## **STAFF MEMO**

### **Planning Board Meeting**

### **Agenda Item #2: 34 Hammond Rd, LLC/J.P. Pest Services – Hammond Rd – Map 43, Lot 70**

#### **Public Hearing for a Major Site Plan**

**SITE & GRADING PLAN**  
MAP 43 / LOT 70  
**J.P. PEST SERVICES**  
34 HAMMOND ROAD  
TOWN OF MILFORD  
HILLSBOROUGH COUNTY, NEW HAMPSHIRE

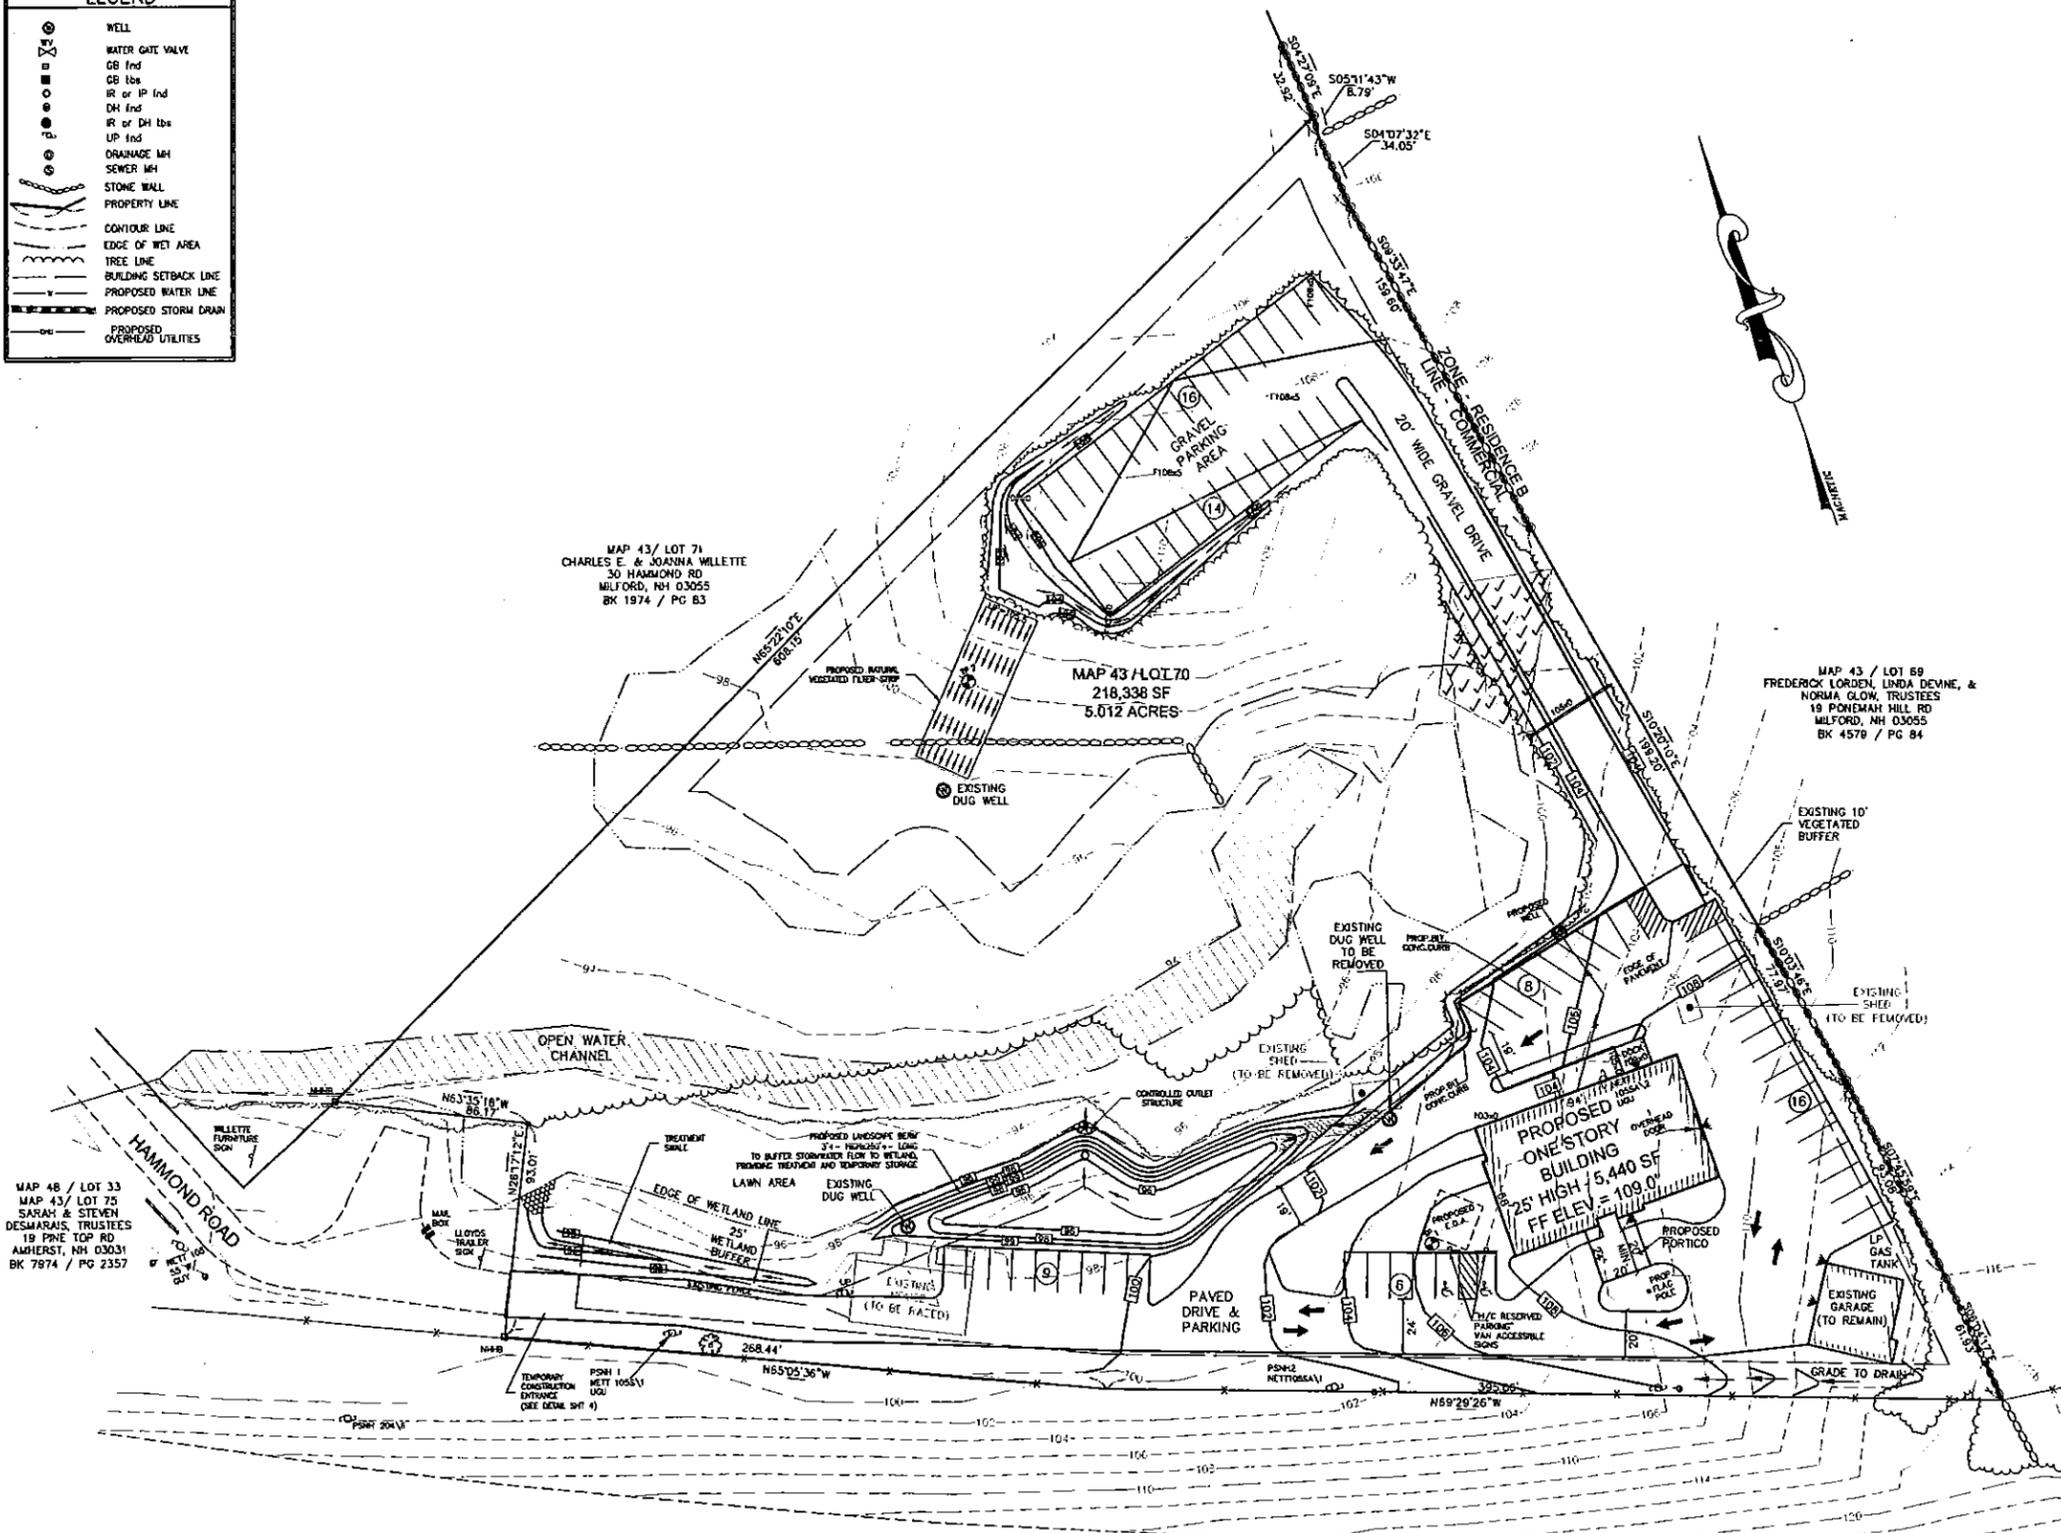
Fire Department - The rear loading dock area has a 4' elevation change from the rear lot to the lower one. Either 6" bollards or a guardrail need to be placed along the retaining wall.

Staff would recommend the Board discuss with the applicant Fire's request to add 6" bollards to the loading dock area. In addition, there are no details on the retaining wall proposed for the loading dock area. The details should be provided on the plan set prior to final approval.

1. Add a note referencing the ZBA special exception approved on July 7, 2011.
2. Update note #6 on Sheet 3 to complete the sentence.
3. Remove note for #4 or 9 on sheet 3 as they are duplicates.
4. The stormwater permit be approved by Code Enforcement.
5. Retaining wall details be added to the plan.
